NAVAL ASSESSMENT AND CONTROL
OF INSTALLATION POLLUTANTS
REVIEW WORKSHOP

NAS-JACKSONVILLE

VERIFICATION STUDY
CHARACTERIZATION STUDY

April 29, 1986

SITE NO. 5 - SHORELINE FILL

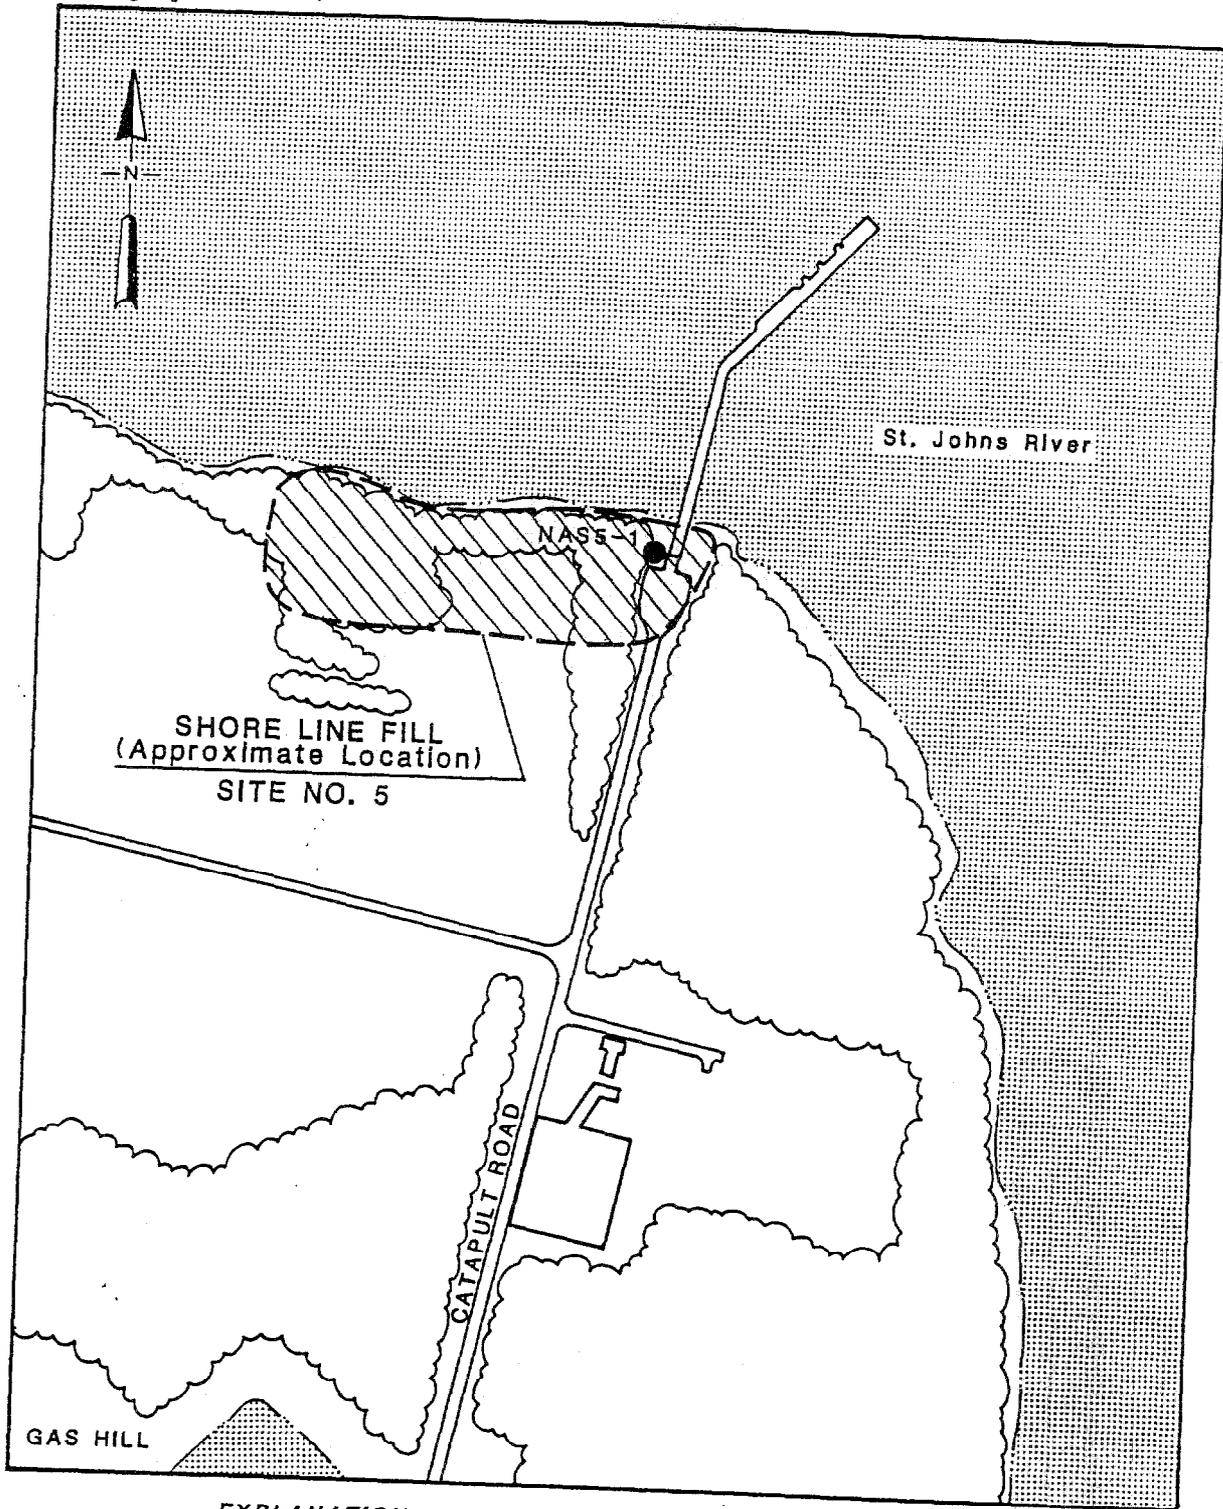
Mr Crane agrees to drop 4-29-84

SITE NO. 7 - GAS HILL

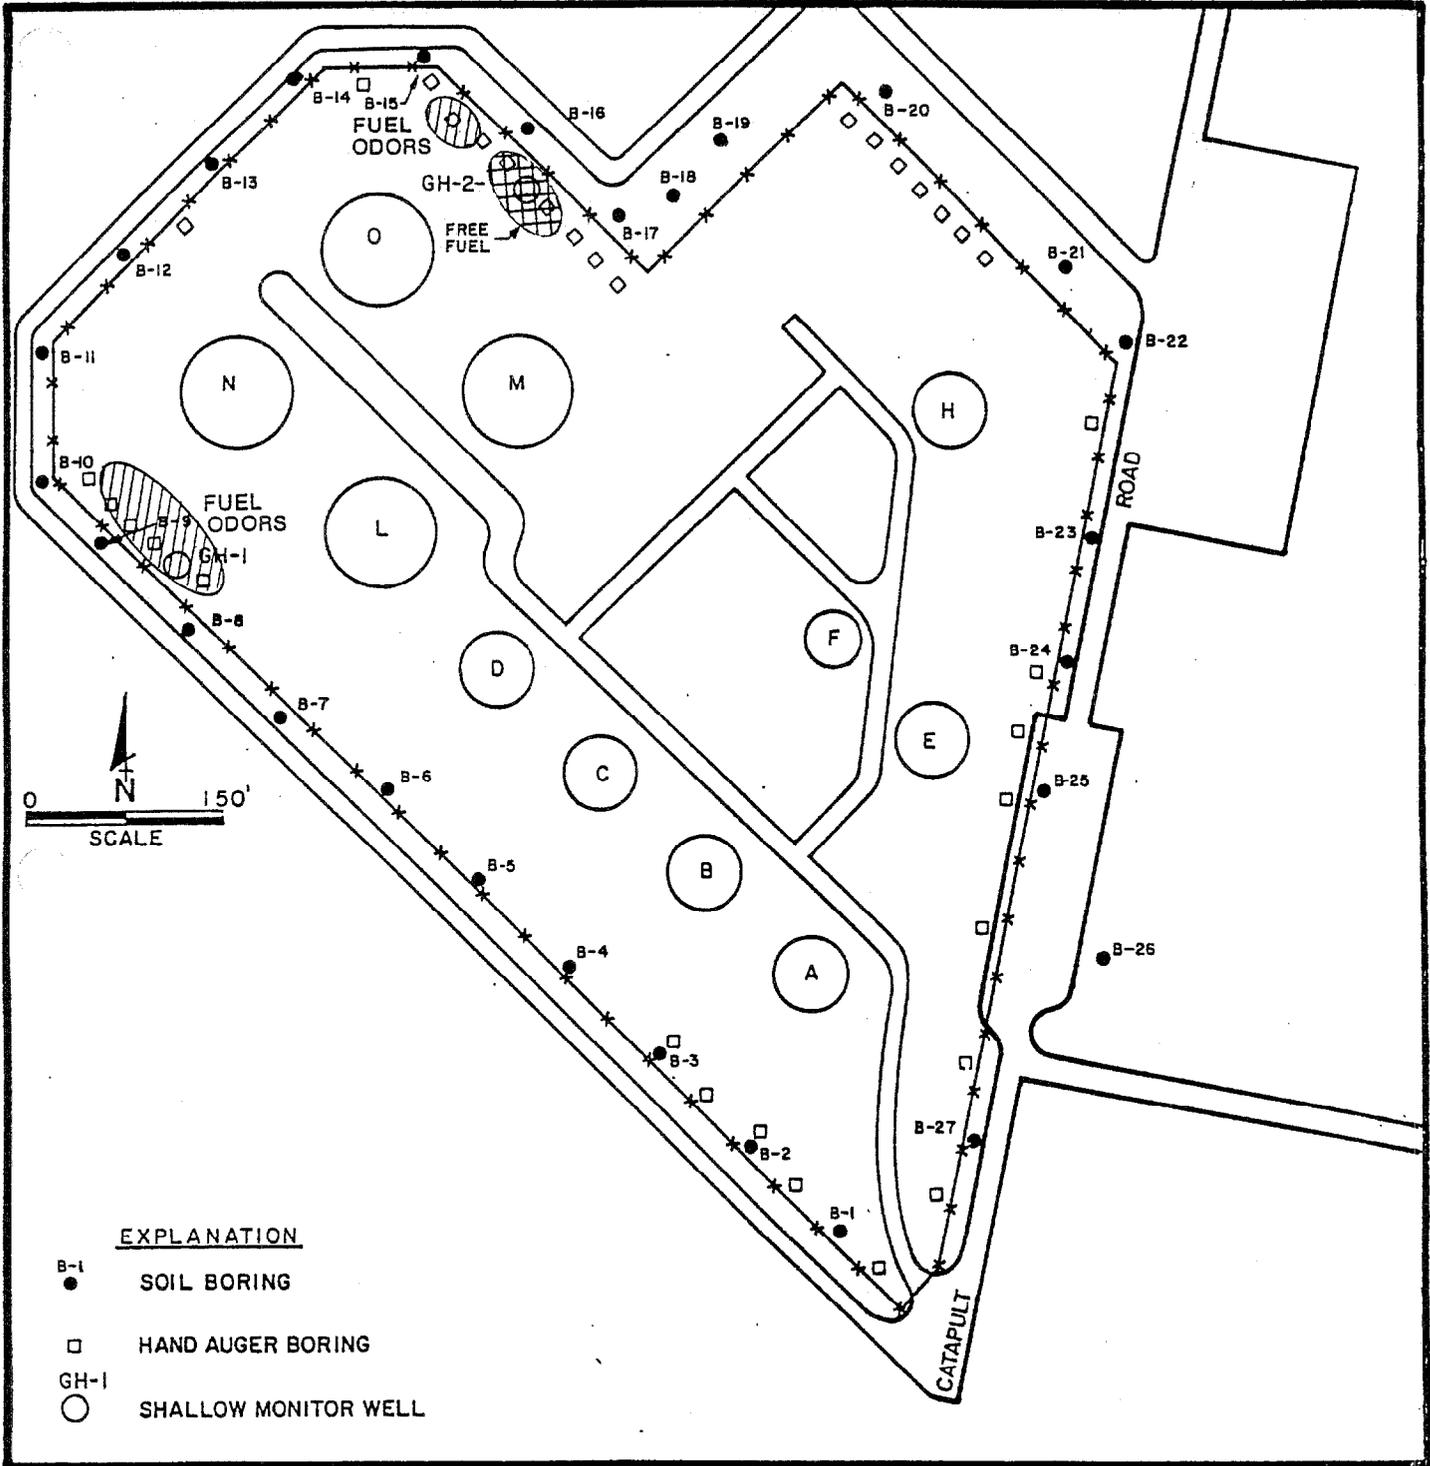
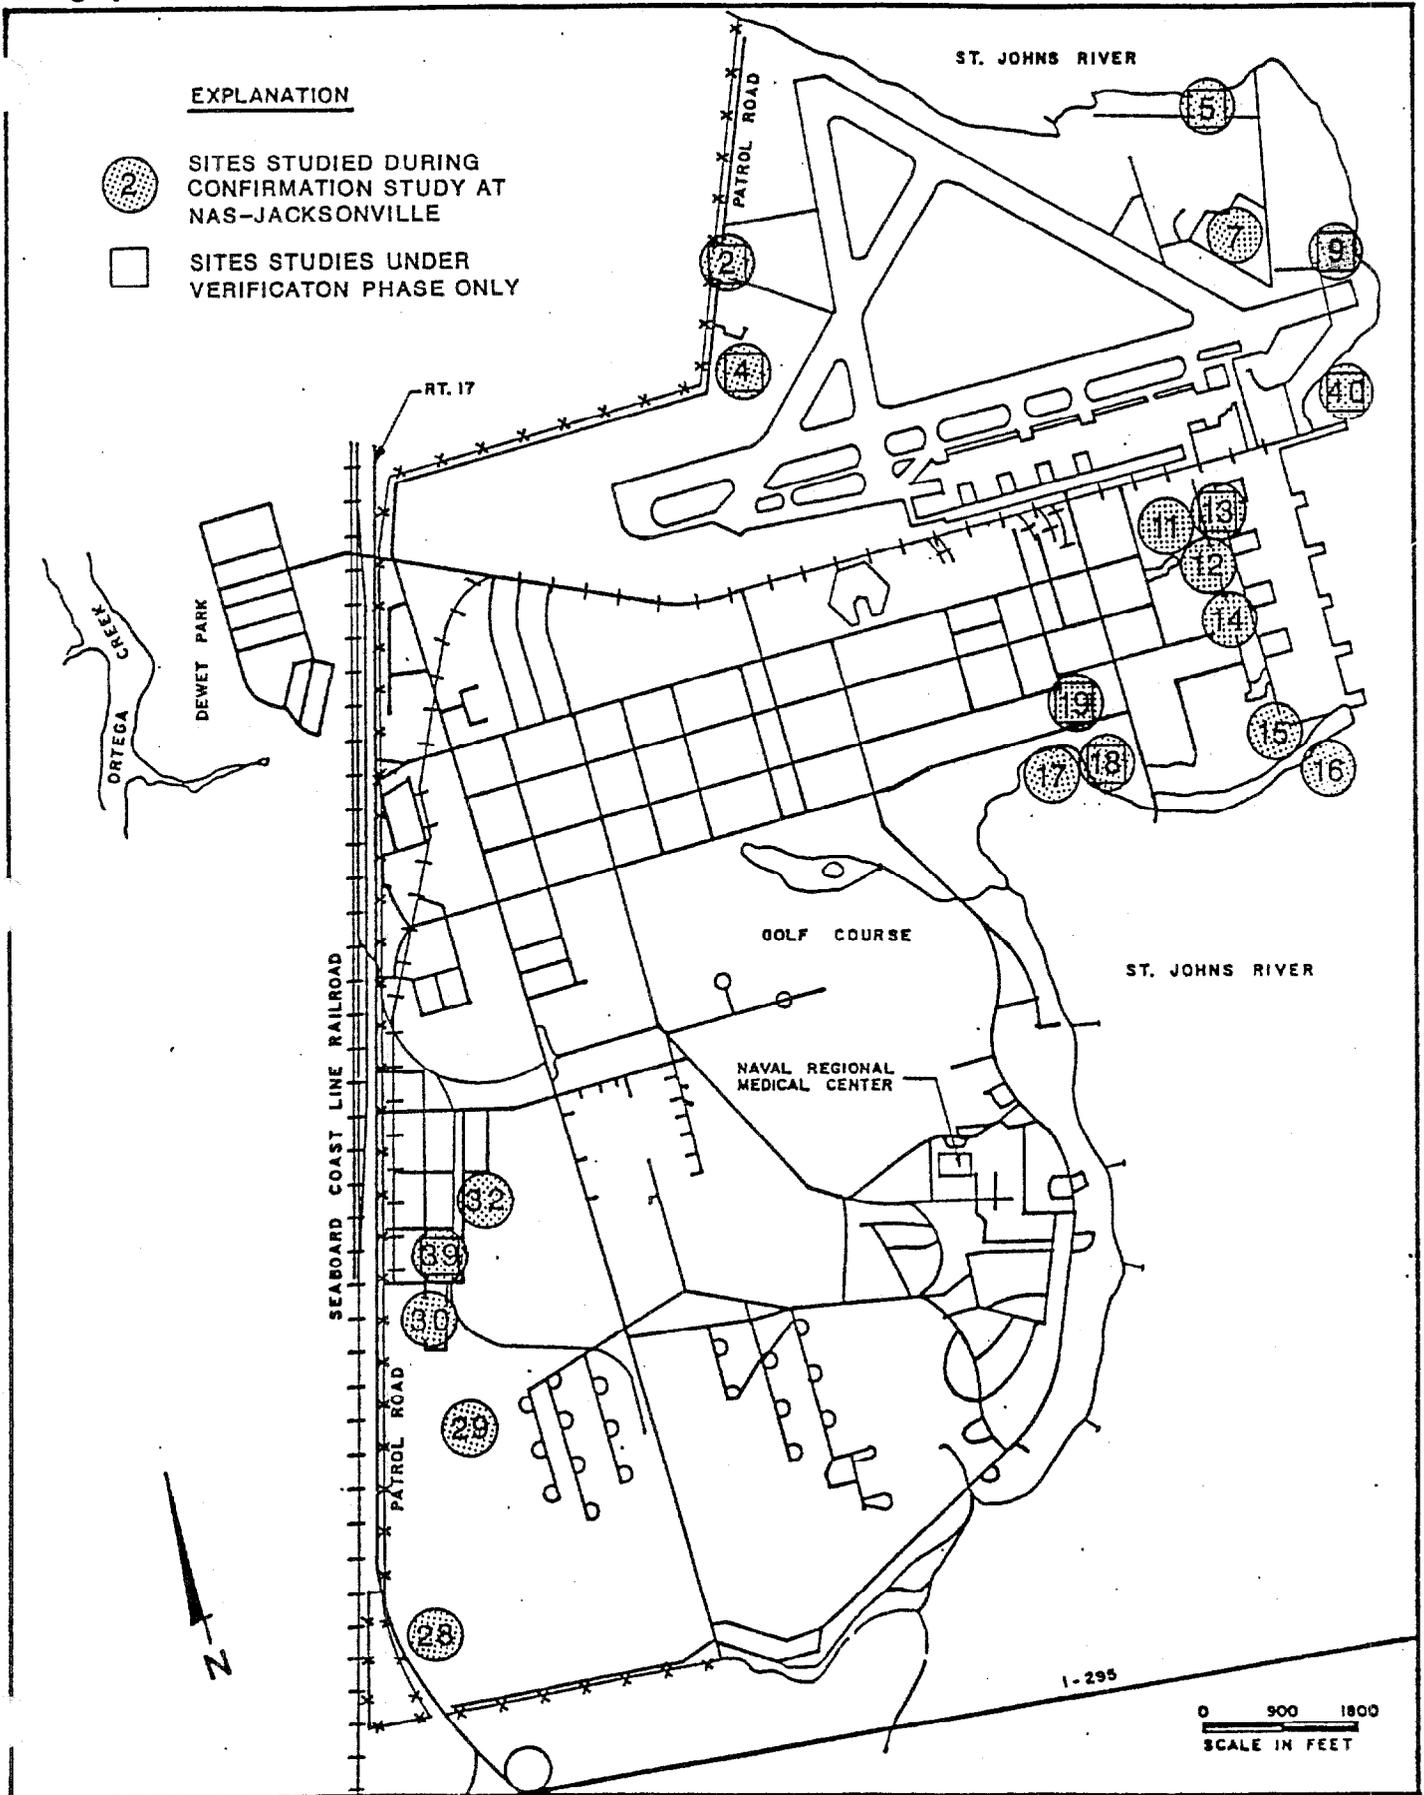
601, ~~602~~, 610 state wants + city wants

Risk assessment . 4-29-84

most down gradient well requires 601

SITE NO. 13 - RADIUM PAINT WASTE DISPOSAL AREA

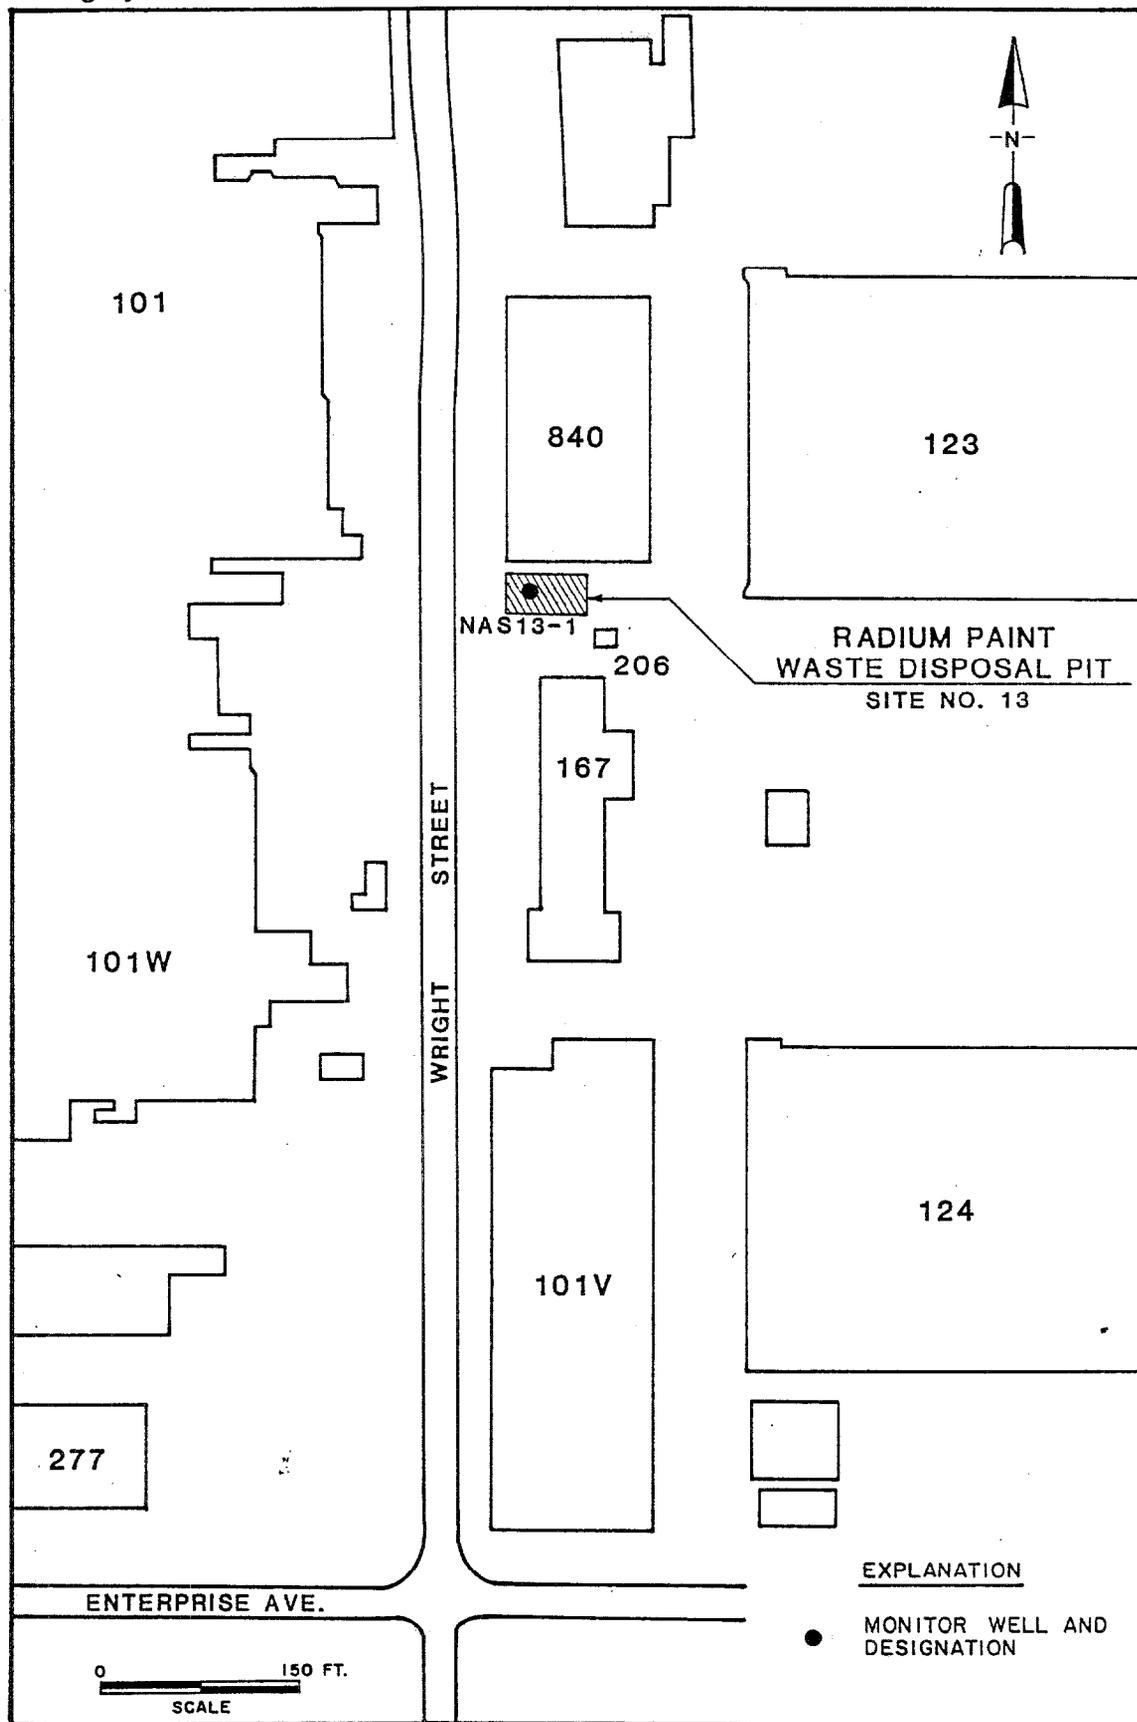
Drop IT
